HISTORIC PRESERVATION COMMISSION STAFF REPORT

CASE NUMBER: 37/3 - 89R

PROPERTY ADDRESS: 16 Valley View

The applicant is proposing a one-story, brick addition measuring approximately 15' x 31' at the rear of this c.1930's 1 1/2 story brick cottage. It will accommodate a new family room and dining room. Also, at the side of the structure, a 10' x 10' mud room/open porch combination is proposed.

EAST ELEVATION

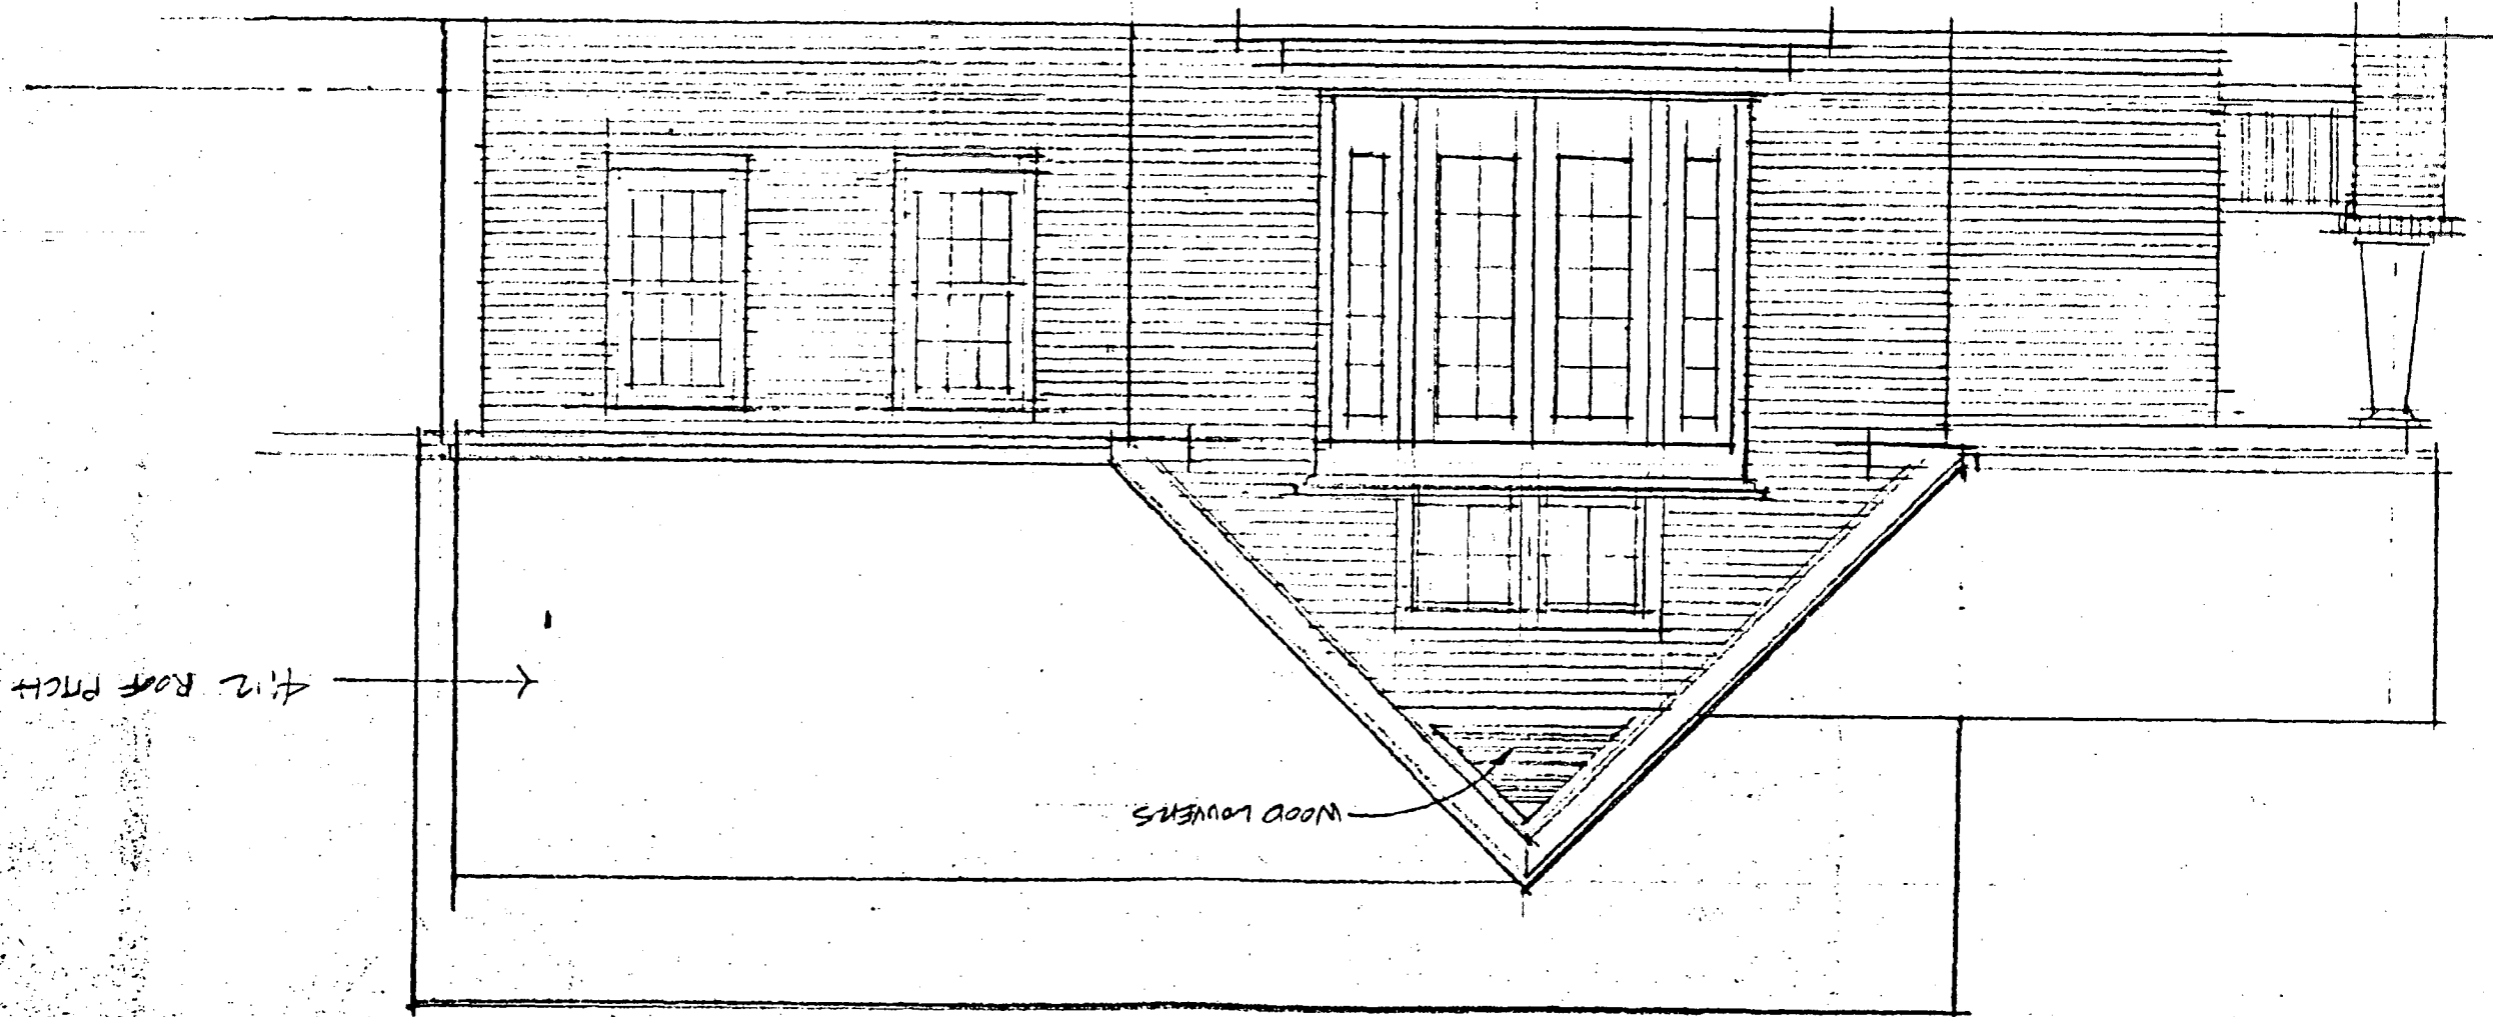
The LAC had recommended that the applicant change the side porch columns from tapered style to standard boxed, but otherwise recommended approval of the application as submitted. Staff concurs, and feels that the proposal would not constitute substantial alteration in the Takoma Park historic district.

On side portico, substitute straight boxed column for battered column, which is not consistent with Tudoresque style of the house. Owner and architect have agreed to make this change
